Transport and Environment Committee

Leith Programme - Objections to Traffic Regulation Order – Leith Walk (Brunswick Street to Montgomery Street) and Redetermination Order – Leith Walk (Brunswick Street to Montgomery Street)

The next phase of the programme to be implemented (Phase 5) will be the section of Leith Walk between Brunswick Street and Montgomery Street. The proposals for this section require both a Traffic Regulation Order and a Redetermination Order. This report details the results of the statutory consultation for both Orders.

The Leith Programme
 Phase 5 - Brunswick Street to Montgomery Street
 Traffic Regulation Order

Drawing 1 of 2

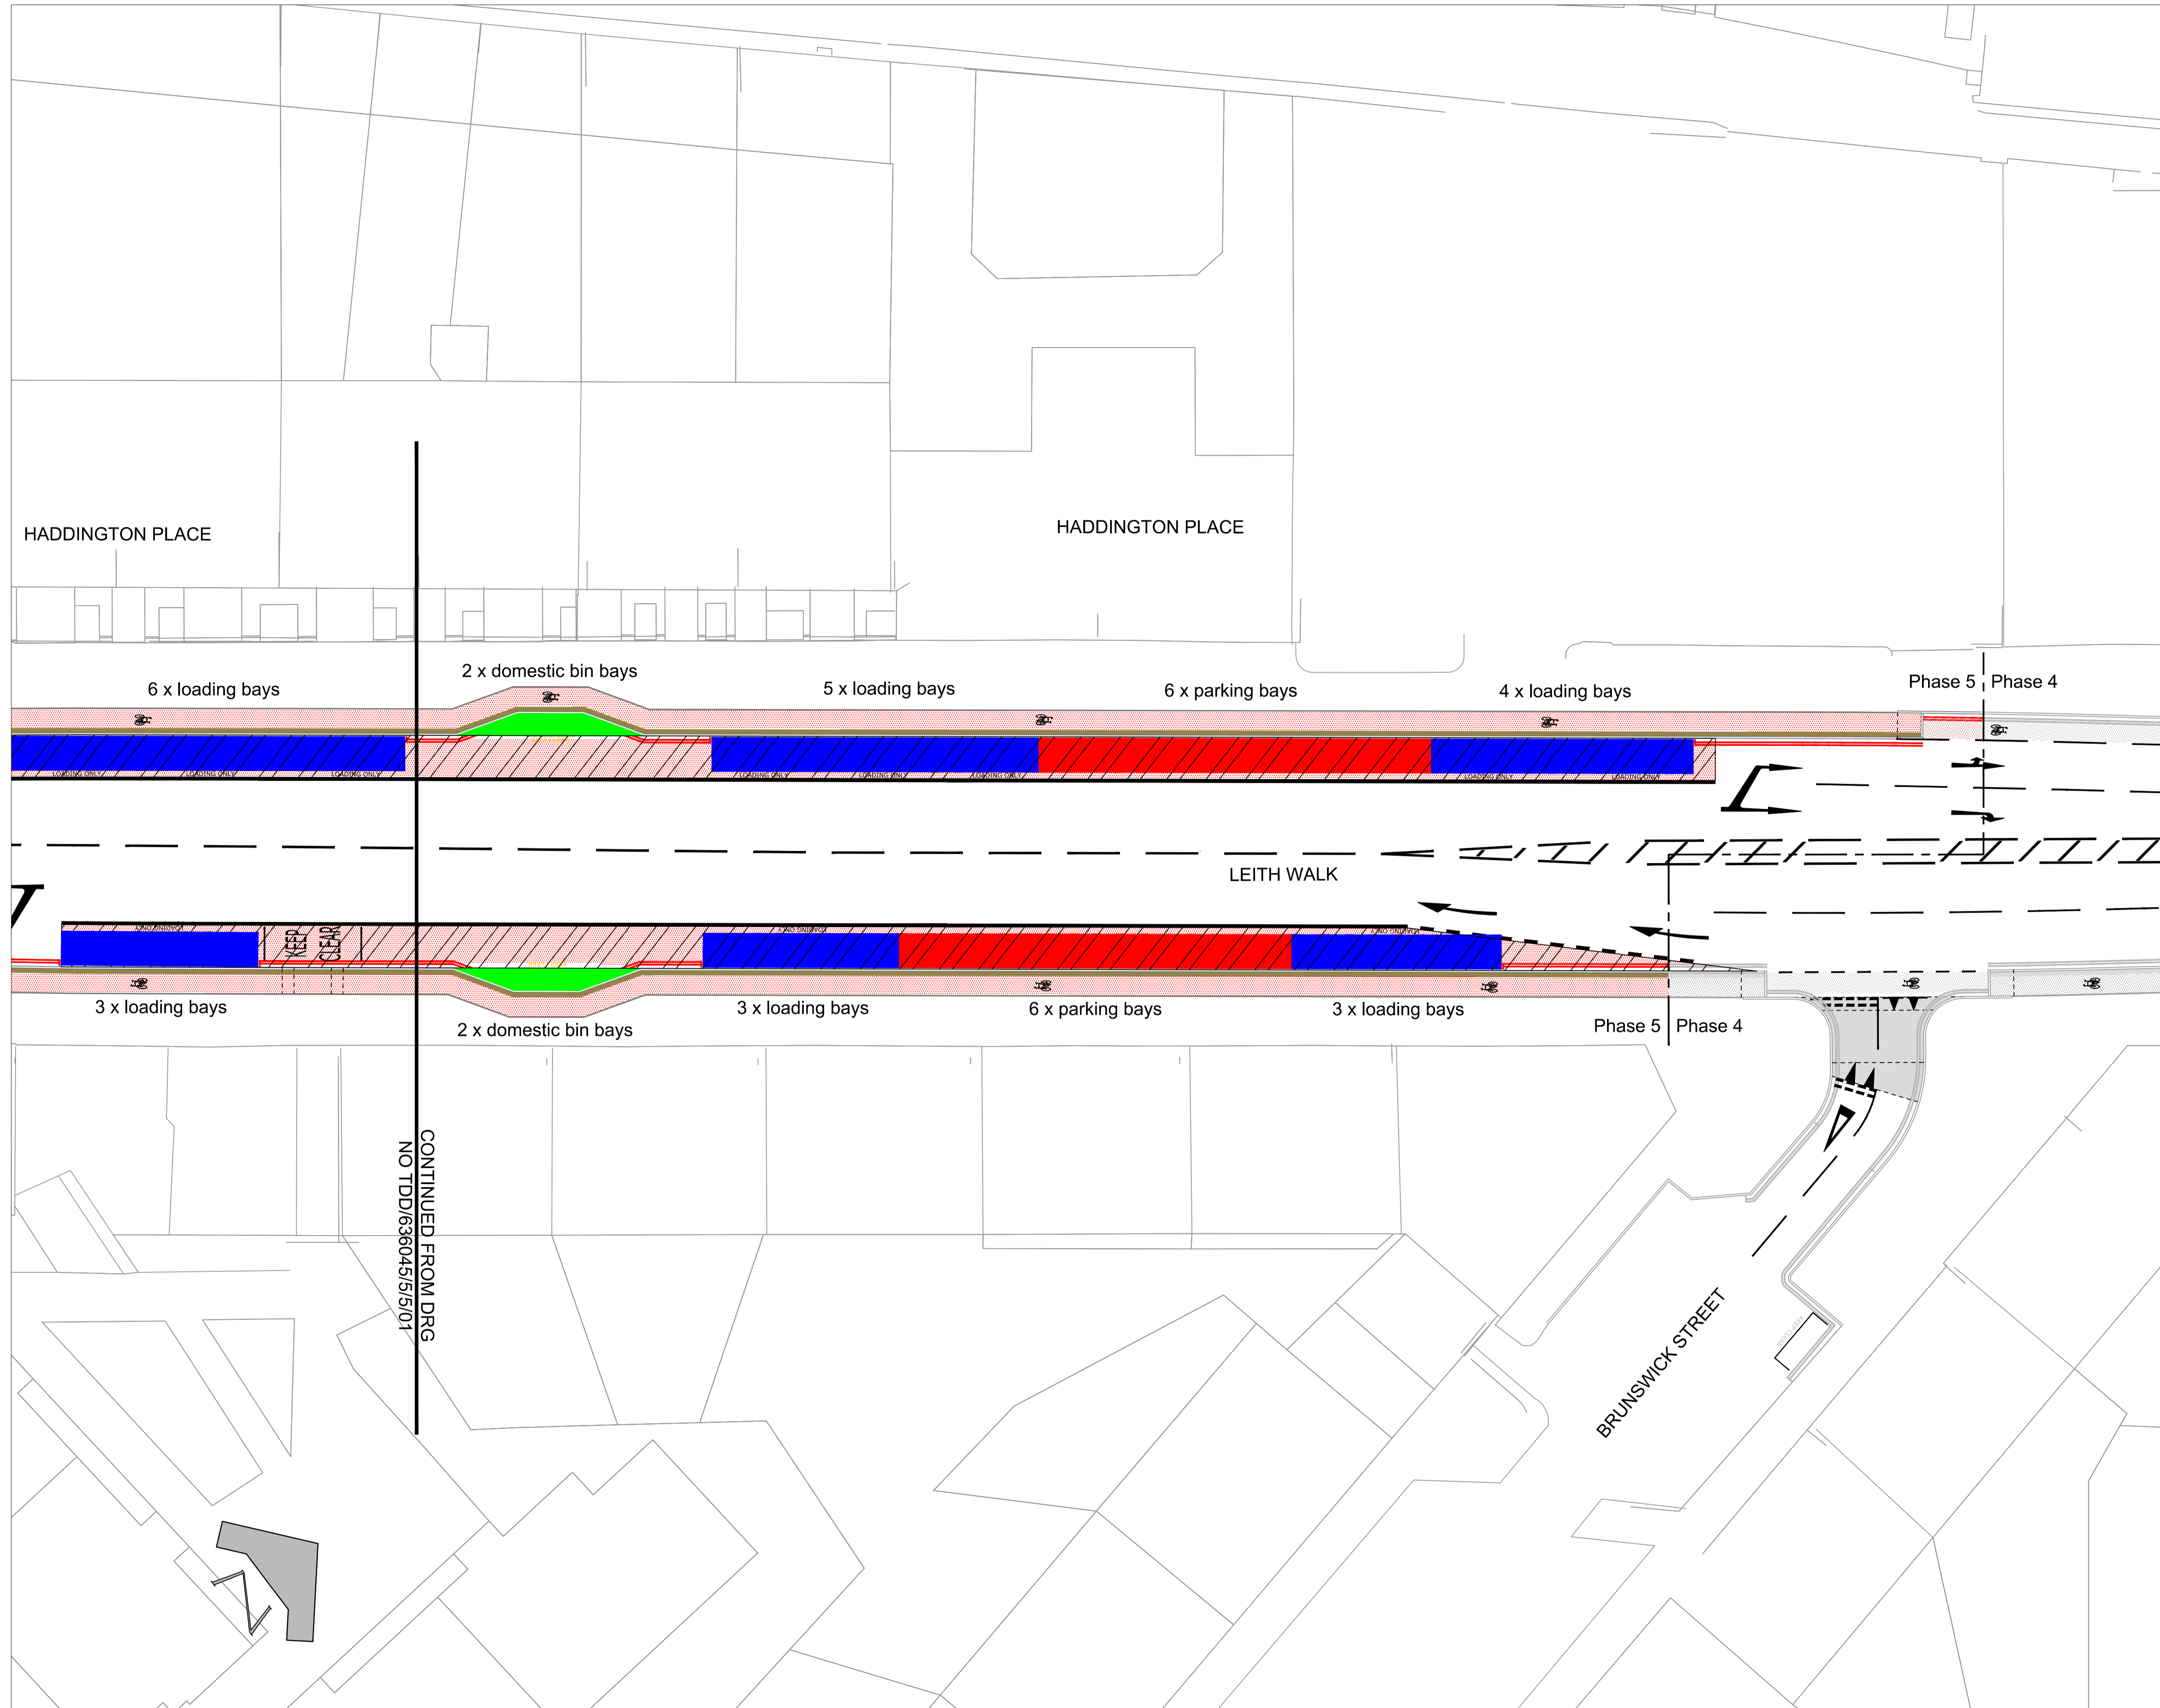
Ref	Detail	Nr Received
1	Prohibition of exit from Montgomery St to Leith Walk	64
2	Prohibition of Right turn from Leith Walk to Montgomery St	50

I have reviewed the plans and it seems that there is technically no proposed prohibition on turning left from Montgomery Street onto Elm Row, but only because the narrow, single-lane road, separated from the body of Leith Walk and immediately next to the row of shops, is also called Elm Row. It seems to be thought feasible to direct significant volumes of traffic along that narrow road. It is not feasible at all, as anyone familiar with the area would tell you. Any car driving along that section of Elm Row and meeting a car coming in the opposite direction will not get by. One or other car will have to park, or reverse. It's like driving in the highlands, with single track roads and passing places. It's very difficult with the present levels of traffic, let alone with a great deal more traffic in addition. The proposal is therefore, in effect, a ban on cars turning out of the west end of Montgomery Street at all.

I also think the proposed change to the lane marking southbound at Elm Row just before Montgomery Street is poorly thought out. At peak times, especially, having only one lane available for southbound traffic seems calculated rather to decrease traffic flow rather than to increase it. Again, there will be attendant increases in frustration, noise and pollution.

Montgomery Street: Prohibition on entry to Leith Walk will increase congestion on Montgomery Street neighbouring streets (including Windsor Street, Elm Row, Brunswick Road,	It is proposed to prohibit entry for vehicles into Leith Walk from Montgomery Street as part of the proposed upgrade to the signal controlled junction at Annandale Street. This will remove the need for traffic signal control at Montgomery Street, allowing a simpler and more efficient junction to be provided that will benefit all road users. Left turn entry for vehicles from Leith Walk onto Montgomery Street will be retained under the new layout as will entry onto Montgomery Street from Annandale Street.	64

<p>Brunswick Street, London Road (and roundabout), Picardy Place, and McDonald Road)</p>	<p>In line with the design principles of the current works, restricting the two vehicle movements highlighted above will allow the proposed new junction to be more pedestrian, cyclist, and vehicle friendly.</p> <p>Traffic counts have been undertaken in order to establish the number of vehicles that currently enter Leith Walk from Montgomery Street. The results show that number of vehicles currently making this manoeuvre is relatively low. Restricting direct access to Leith Walk from Montgomery Street will result this traffic seeking to use alternative routes, however displacement is likely to be onto a number of alternative routes, some using adjacent streets and some further afield as part of a more strategic re-routeing. Given the relatively low volume of displaced vehicles, it is not considered likely that there will be an unacceptable increase of traffic on the various alternative routes. As such, the Council does not expect displacement to cause a significant problem on any individual route.</p>
